Inspection Report

Station: Mitchell Unit: 1 Report Name: 1-WATER WALL FRONT

AREA: Water Wall Front

Record:# 15

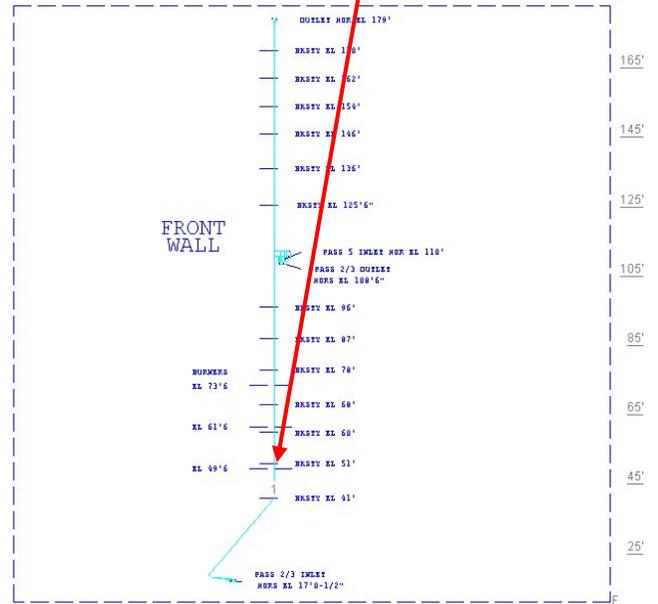
Replace 1' section of **Tube 243** adjacent to Burner 13C due to Soot Blower erosion and a RWT of 0.103. The area is marked with white paint stick.

Record:# 18

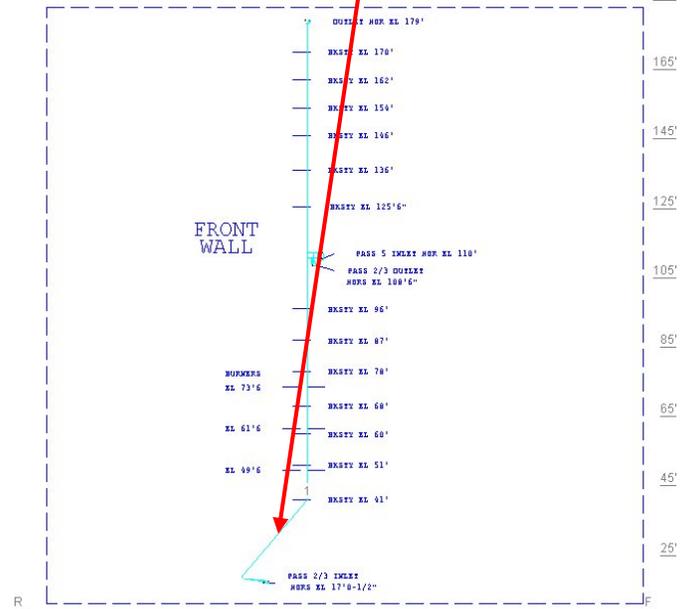
Install 6' Dutchman on **Tube 279** due to fly ash erosion and a RWT of 0.141. The tube is located on the left side of the Division Wall and the cut lines are marked with white paint stick.

Record:# 6

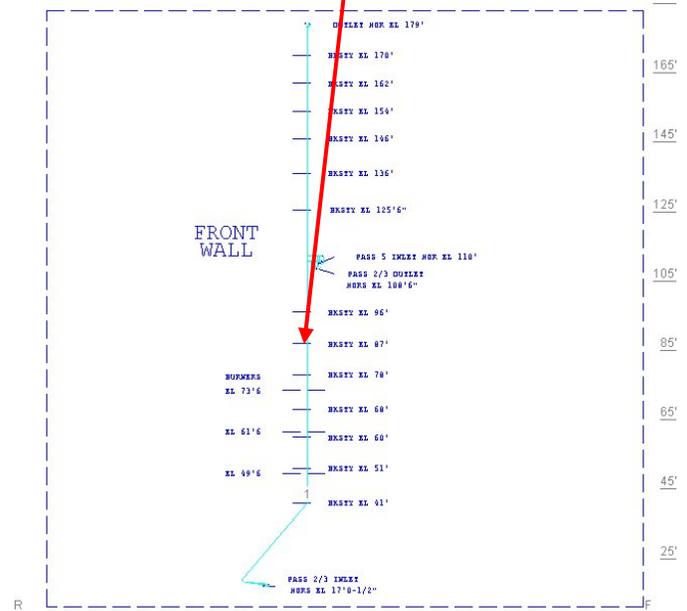
Apply one 1"x4" pad weld to **Tube 1** due to previous soot blower erosion from the left side wall IR#1.

The eroded area on the tube is just above a previously installed 1' dutchman.

Record:# 22

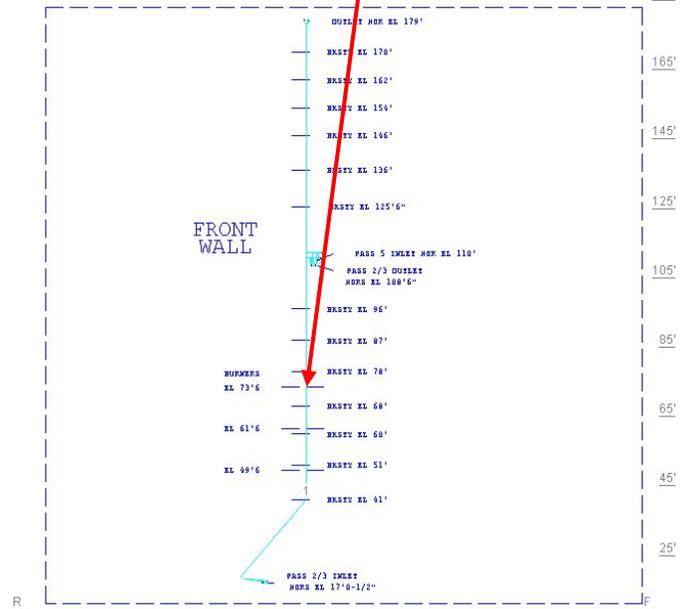
Apply one 1"x2" pad weld to restore **Tube 517** due to erosion from a previously in-service IR. The RWT was measured at 180".

This elevation is equal to the centerline of the upper burner band.

Record:# 49

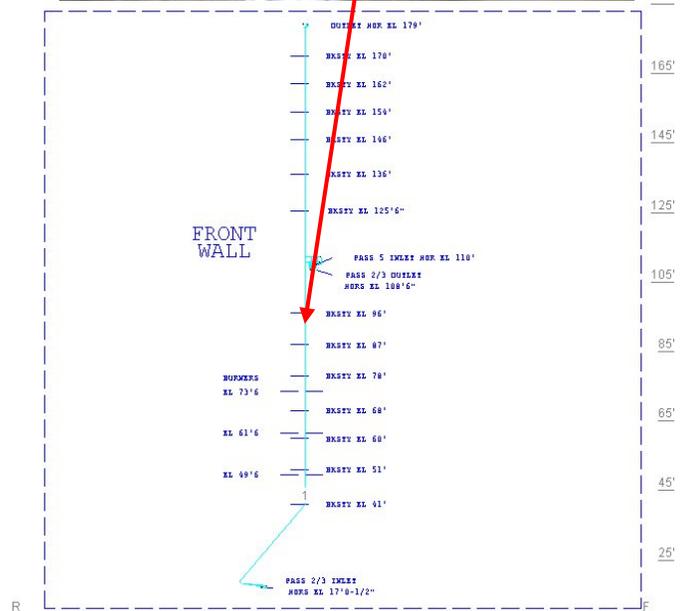
Grind out and weld restore T3 at the front wall due to a wafer wheel cut of a depth estimated >1/16".

Record:# 11

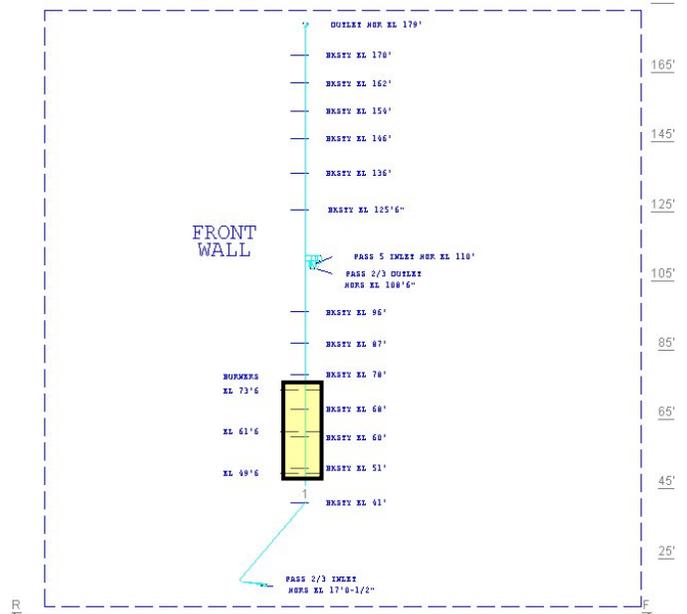
The outer edge of refractory is missing and broken back on the majority of front wall burners throat tubes.

Repair/Replace the missing Refractory.

Record:# 14

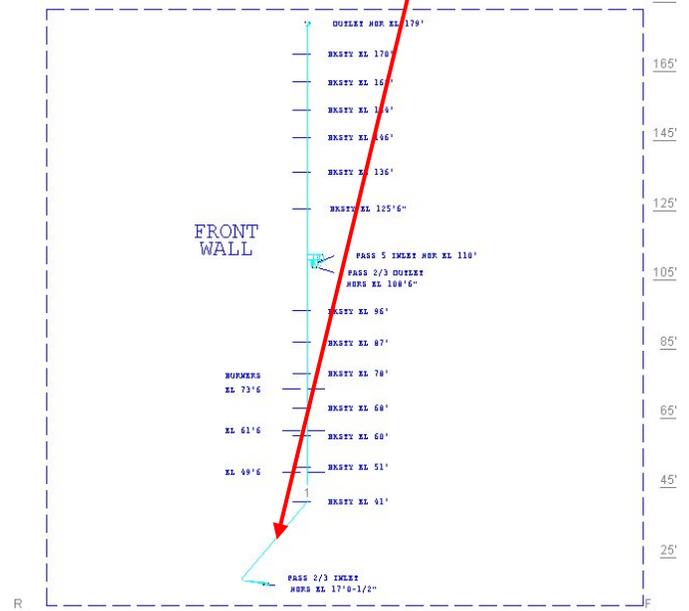
Seal excessive gap at the front lower slope and left side wall junction along the entire length to prevent ash accumulations in the dead air space and to prevent air in/out leakage.

Record:# 24

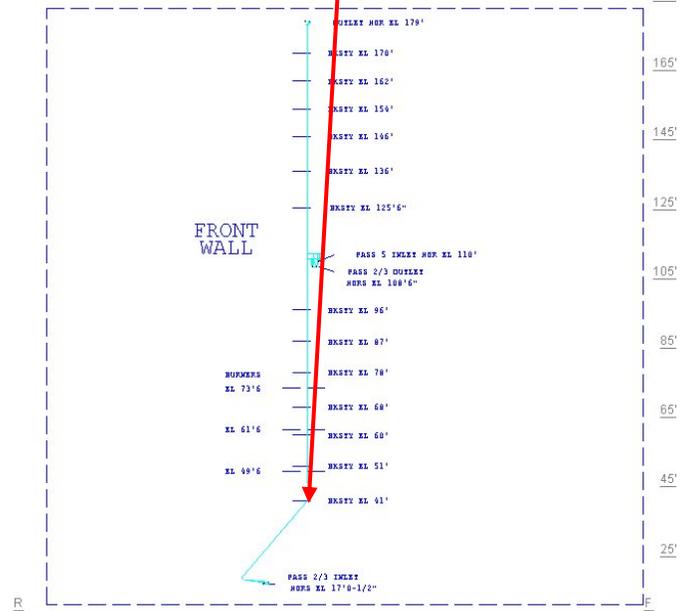
Replace burnt outer casing and install refractory at the junction of the front and right walls to fill the excessive gap caused by the deflection of the lower right wall. This is at the transition to the lower slope.

Record:# 28

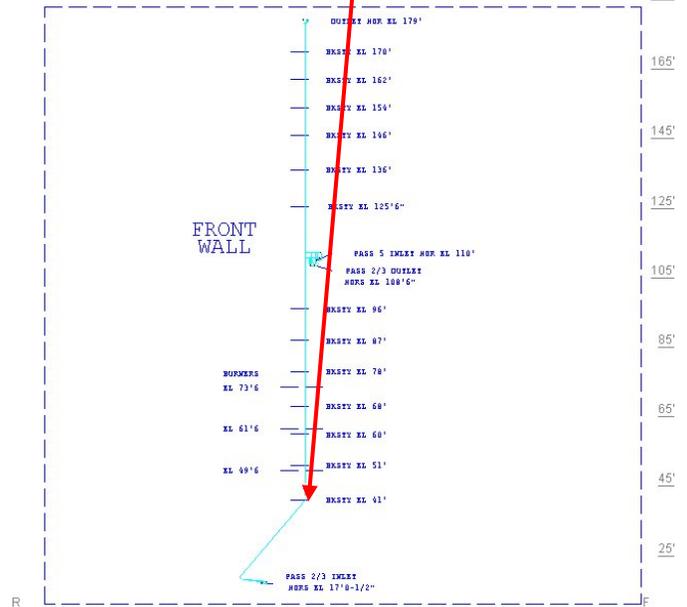
Further research is recommended at **Tube 282** on the right side of the Division Wall.

Verify that the missing material and fatigue cracking is in the overlay and not the tube.

Replace tube if defects are in the actual tube material. Length will be approximately 6'.

Record:# 20

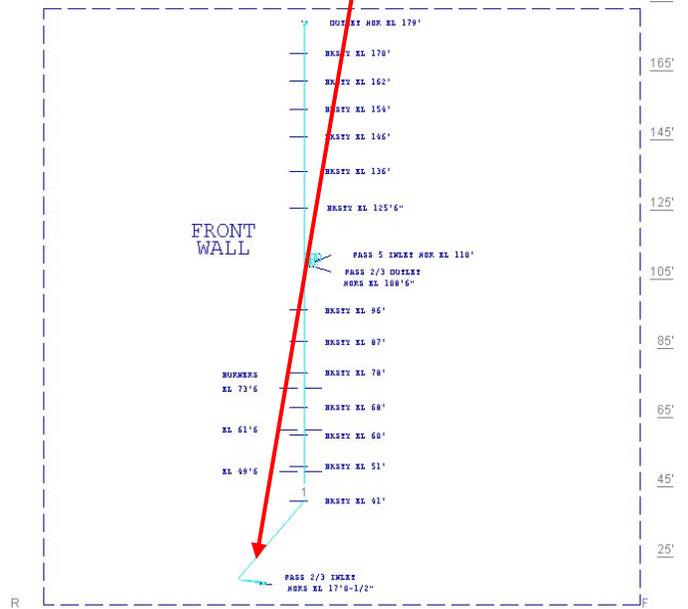
Re-Weld the cracked membrane in between tubes 299 & 300, 303 & 305 due to thermal fatigue. The cracks range from 1' to 5' in length.

Record:# 3

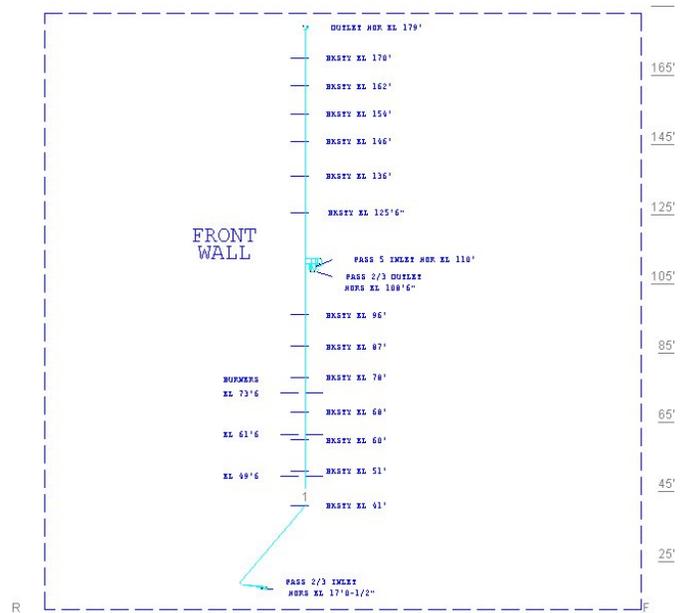
Inspections of the front wall (left and right sides of the division wall) were limited due to the position of the sky climber as it was consistently 2'-3' from the wall.

Record:# 8
Action: INFORMATION ONLY-P3
Priority #: 3
Inspector: Meador K.

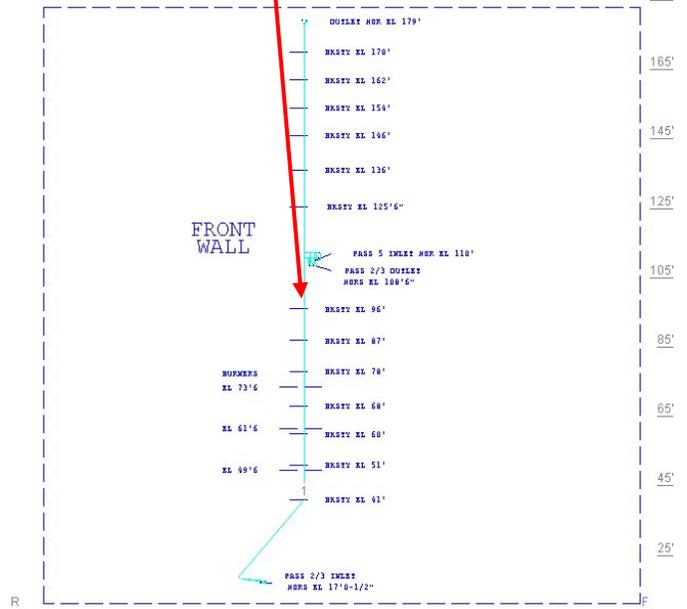
The Water Cannon on the left Front Wall is cracked; however, no action is needed at this time.

Record:# 26

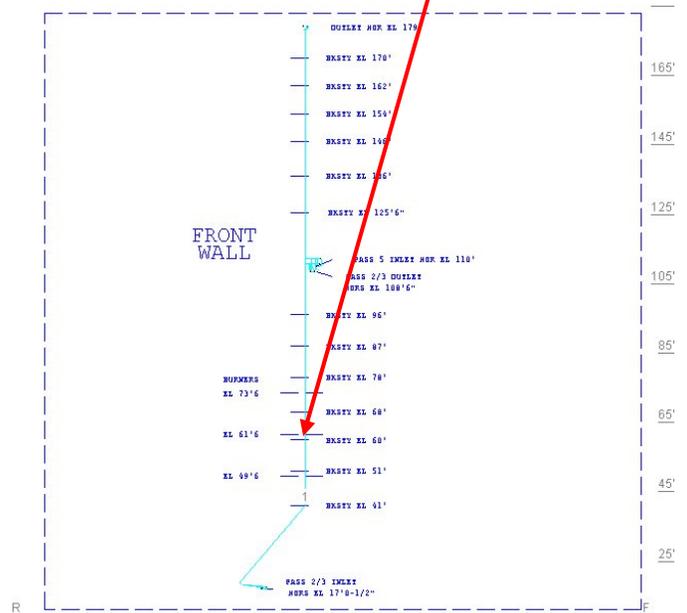
Replace the missing ceramic liner tiles at **Burner #12F** in the 11:00-12:00 o'clock positions.

Record:# 7

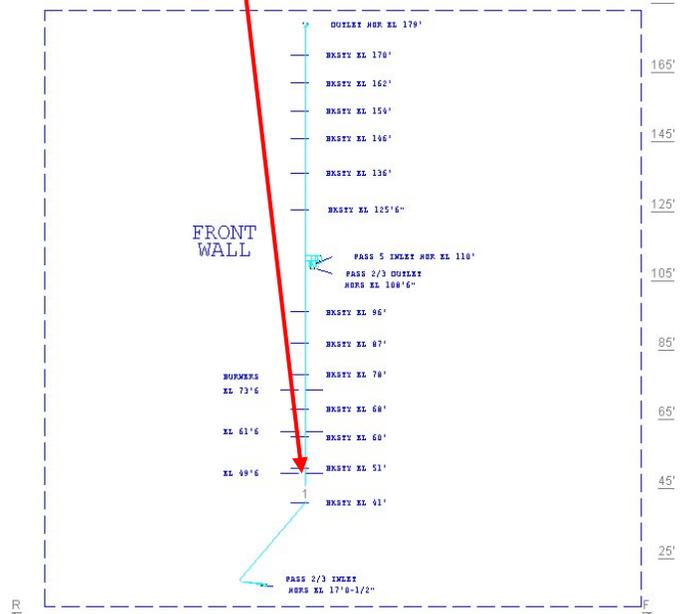
Replace Coal Nozzle Tip due to thermal fatigue. The Coal Nozzle Tip on Burner 13C is distorted at the 7:00 position.

Record:# 7

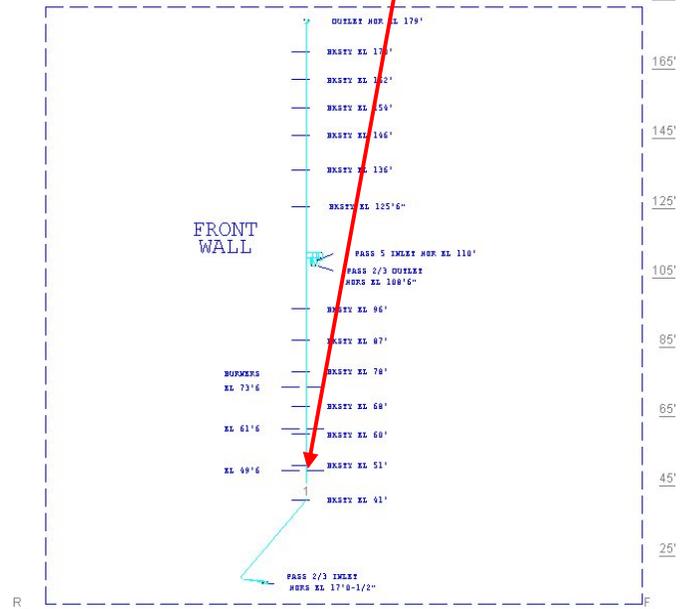
Replace the conical diffuser at **Burner 13C** due to thermal fatigue cracking in several locations.

Record:# 42

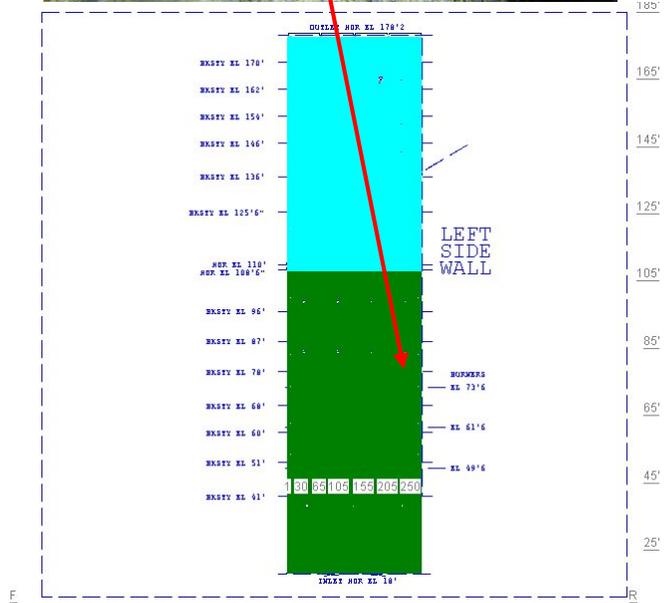
Grind surface indications to termination and then verify that the indications are limited to the overlay material only and not the actual tube surfaces.

Should indications continue beyond the overlay, determine the RWT of the underlying tube material and repair as needed.

The area where the damage was located was between tubes 209 and 245 and started at the IR and extended vertically approximately 5'-6' above the IR path. The worst of the damage is located around the IR.

Grind until visible defect reaches termination and call for re-inspection.

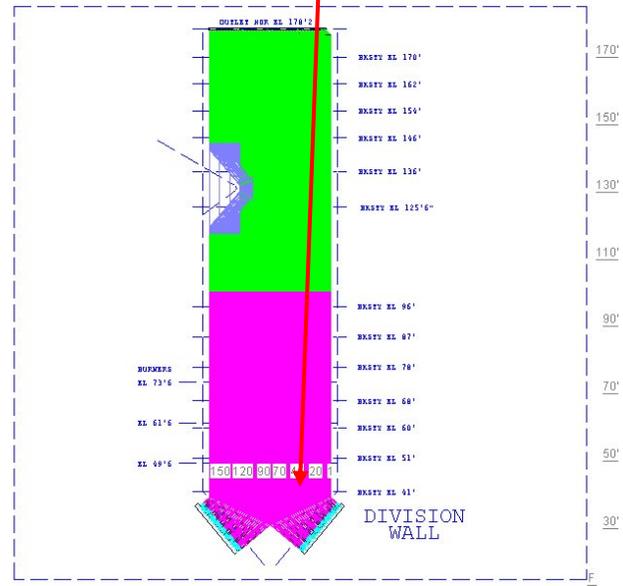
Replace an approximate 15'-20' section of material at **Tube 42** due to abrasion and a RWT of .212".

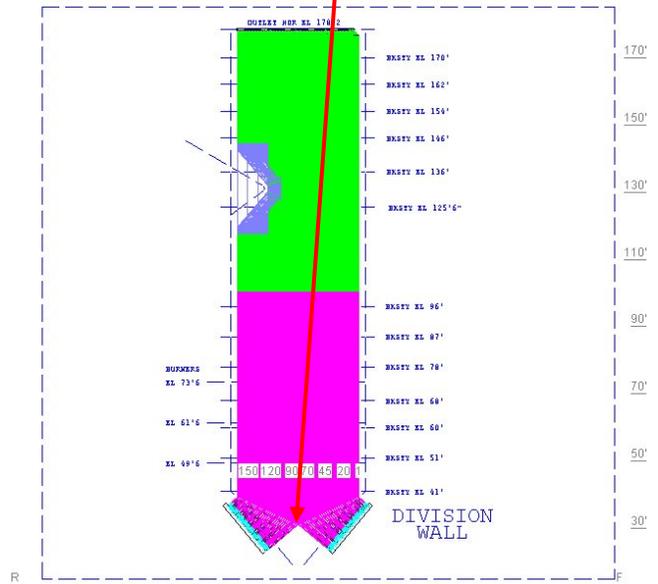
Provide access to the bottom side of the
division wall in the middle at **tubes 84
and 85**. The two tubes appear to be
abrading on each other during operation.

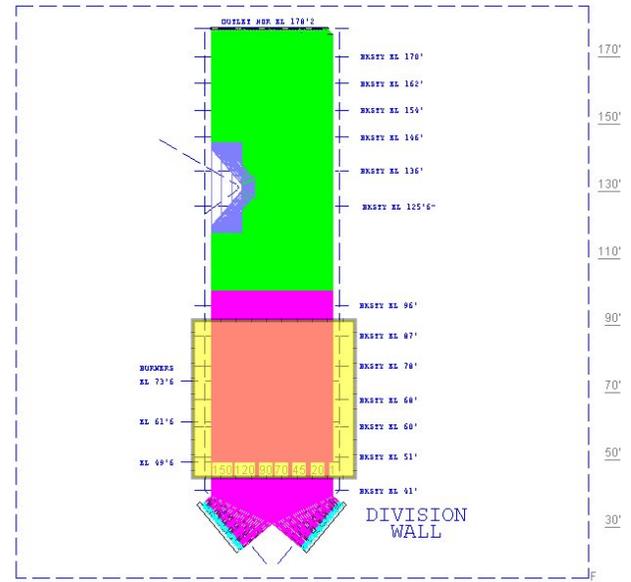
Tube surfaces on the right side of the wall
display a general form of corrosion wastage
consistent with Fire Side Corrosion. The
total affected area begins at or about tube
50 through tubes 110 and extends up the
wall for a height of about 30-40 ft.

The worst area seems to be more
concentrated from about tubes 70-95 within
the burner zones (elev.49'-73') where
attempts at random UT readings revealed
possible RWT's of .125" or less. Confidence
of the UT readings was medium to low due to
tube surfaces and it is therefore recommended that an action plan be established
to address the need and extent of repairs by tube sampling and/or UT scanning.

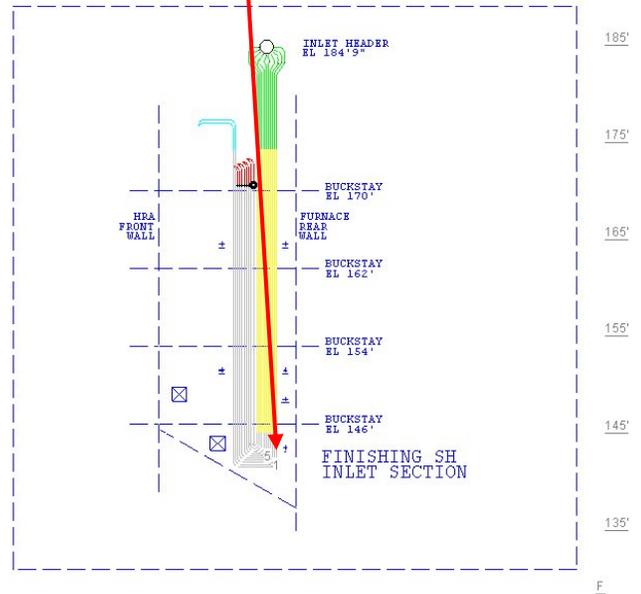
Replace tube sections due to soot Blower erosion. The replacements should start at the vertical field weld approximately 3' above the 90 degree bend and extend 1' pass the horizontal bend on the following:

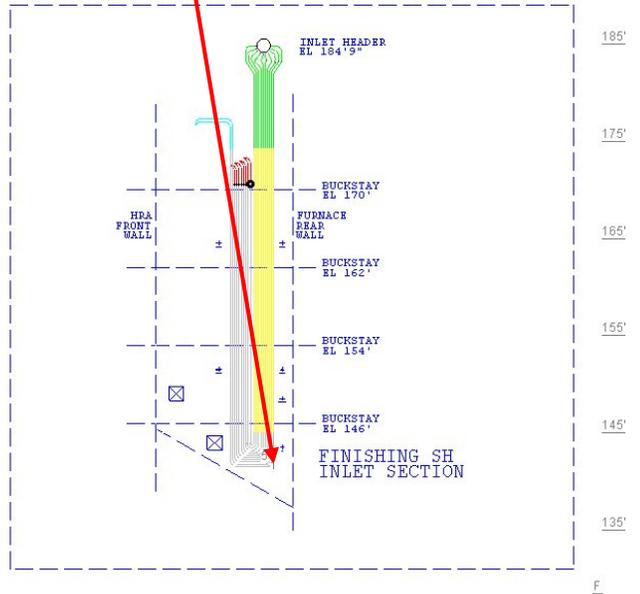
Replace 6' section of the following tubes due to Soot Blower erosion. The replacements should start 1' off the 90 degree bend on the horizontal section and extend to the field weld on the vertical section on the following:

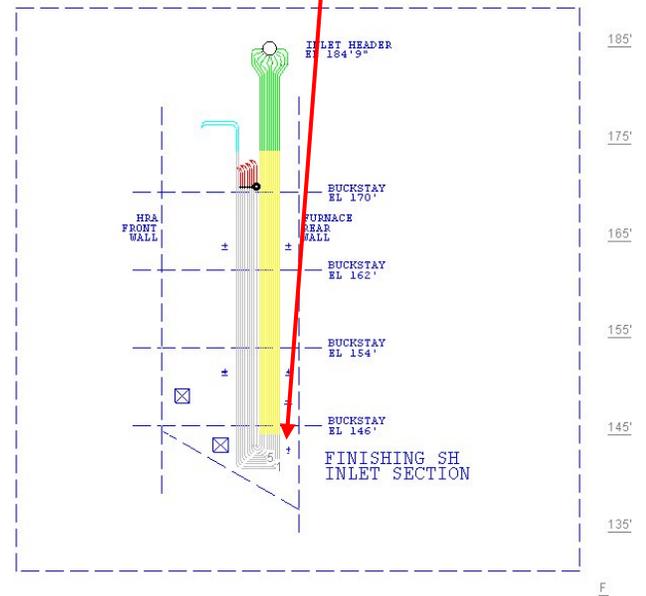
Attach hand cuffs to tubes 1-20 for realignment and replace broken hand cuff on assembly 39.

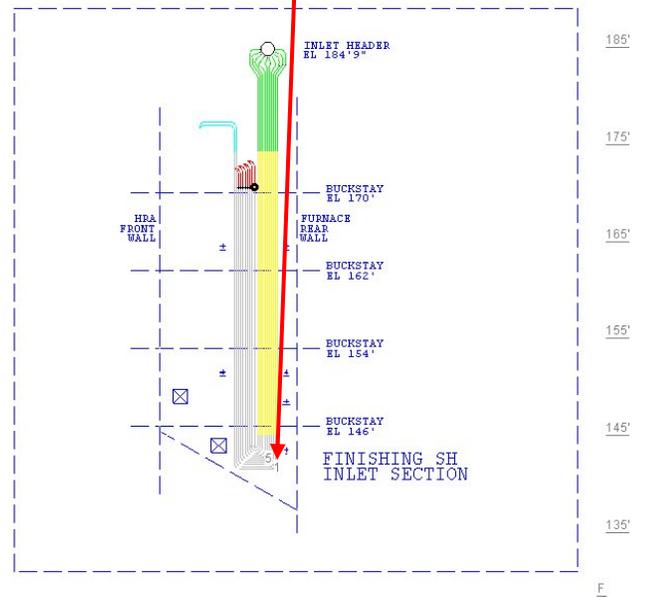
Apply shields to the following pendants/tubes/ UT readings, (all locations require 1' around 90 degree radius with 3' extension going up.

- 8/4/.490"
- 22/1/.504"
- 22/2/.500"
- 23/7/.510"
- 25/5/.479"
- 25/19/.498"

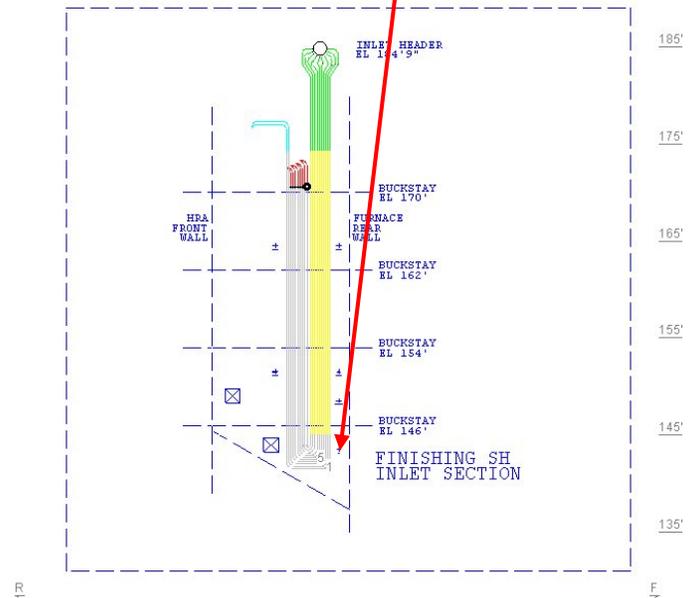
Replace Soot Blower lance sleeve due to thermal fatigue.

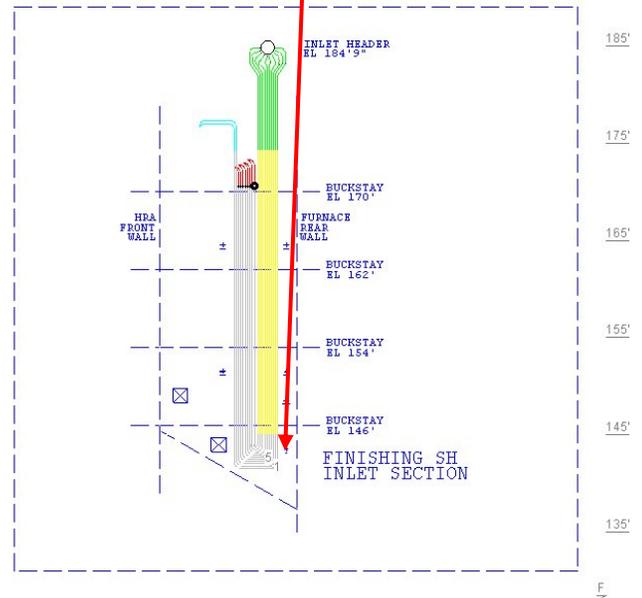
Replace missing Refractory around IK-7/8 due to thermal fatigue.
